IEEE 802.3 Maintenance Task Force

12th July 2017

Adam Healey
Chair, IEEE 802.3 Maintenance TF
Vice Chair, IEEE 802.3 Ethernet WG

Possible project schedules

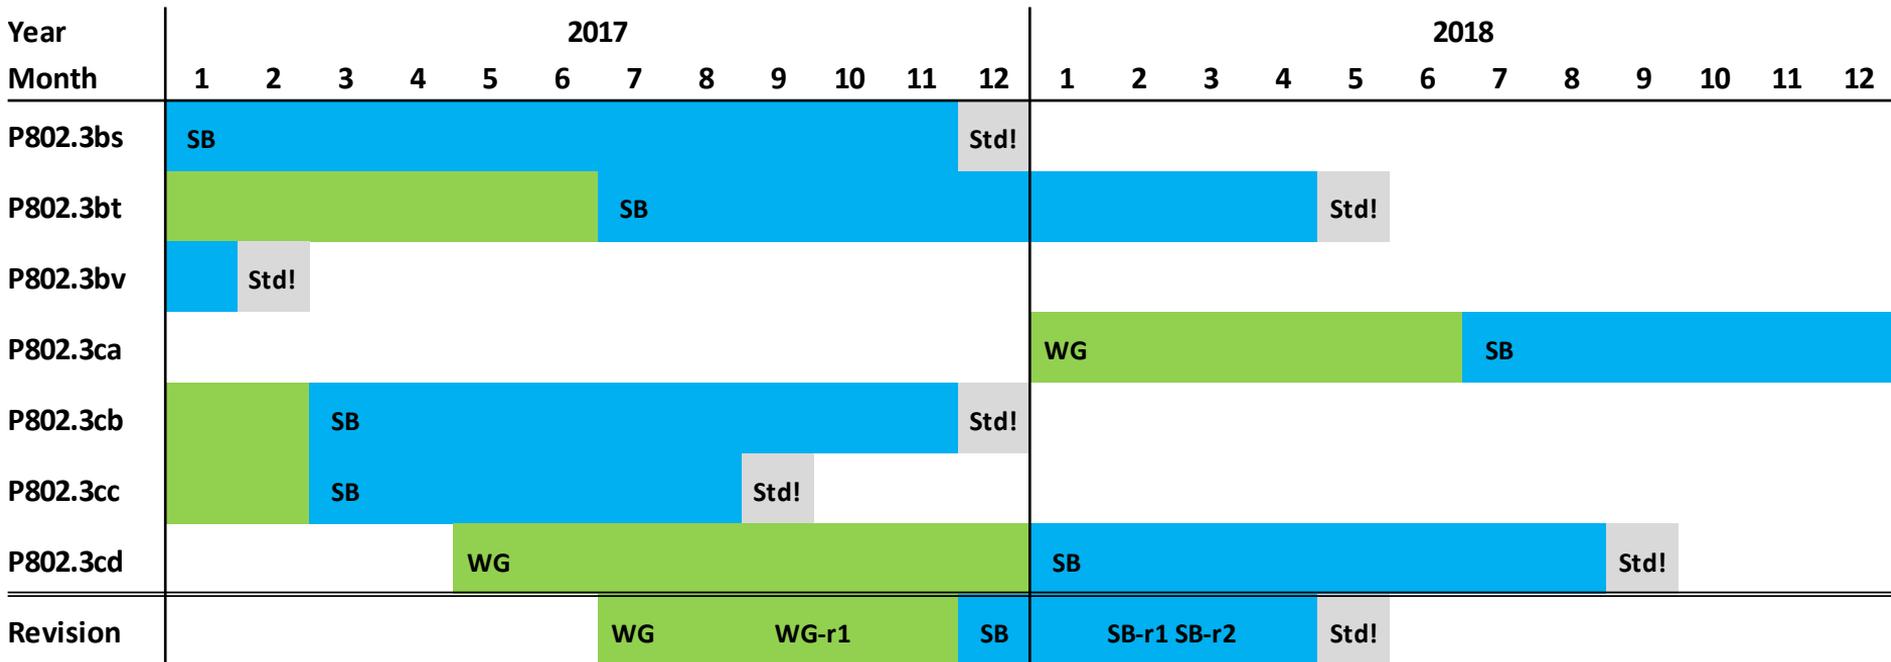
← Comment to include recently approved amendments
